**MANDATORY**  
**SERVICE BULLETIN**  
**MSB-2009-001**

**SUBJECT:** Revised Support Clamps

**MODELS AFFECTED:** All Cessna 177RG aircraft with PFS-13706 exhaust systems installed (See Table 1 for Aircraft Applicability).

Figure 1

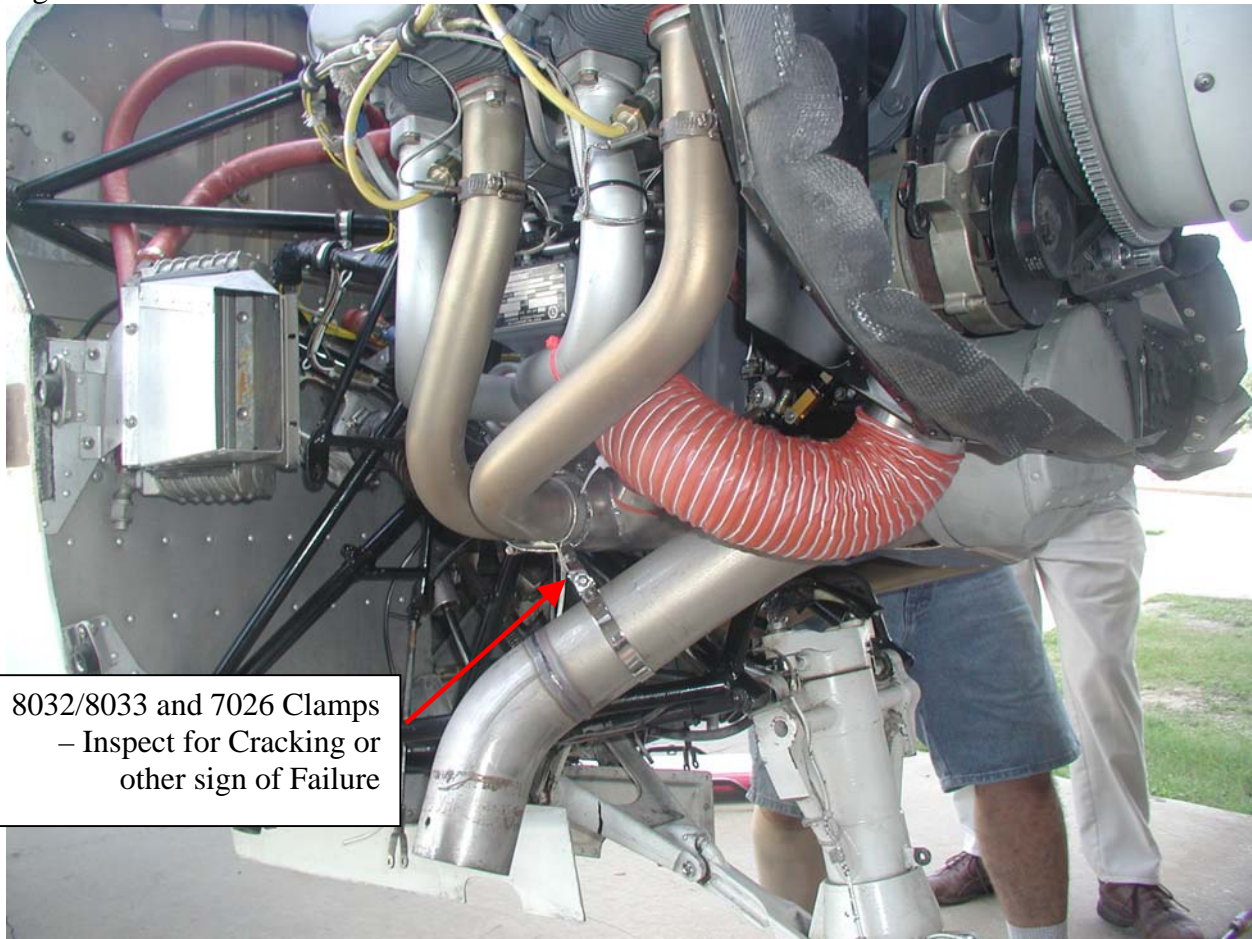
**DESCRIPTION:** In the short time since the introduction of this exhaust system, there have been several failures of the P/N 8032 and 7026 clamps that attach the intermediate tube to the number one header pipe. While this is not the only means of securing the intermediate tube to the rest of the exhaust system, the clamp does help ensure proper tailpipe angle. The original clamps were 0.50" wide\*.

We have developed two wider (0.75" wide\*) replacement clamps (P/N 8033 and 7026 Rev A) and will be providing them free of charge to all affected customers. Please inspect both clamps before your next flight, looking for cracking or detachment. If either clamp is cracked or has otherwise failed, replace both with the new clamps before further flight. If the clamps are not cracked or otherwise damaged, you may continue to use them until the next scheduled maintenance (oil change, annual, etc.). If you elect to continue to use the clamps, note how much tailpipe movement is present. If a future preflight inspection yields more tailpipe movement, the clamps should again be inspected.

**CORRECTIVE ACTION:** Install the clamps included with this Service Bulletin.

Remove the existing clamps by removing the hardware that joins them. Install the new clamp in the same manner as the original, discarding the old clamp. Please keep in mind that if you did not receive two clamps, you will need to reuse the 8033 clamp (the larger of the two). It may be necessary to pull forward on the bottom of the intermediate tube while tightening the clamps to ensure sufficient clearance to the engine mount. See the included installation instructions for additional details. Make a logbook entry stating that you have complied with this service bulletin.
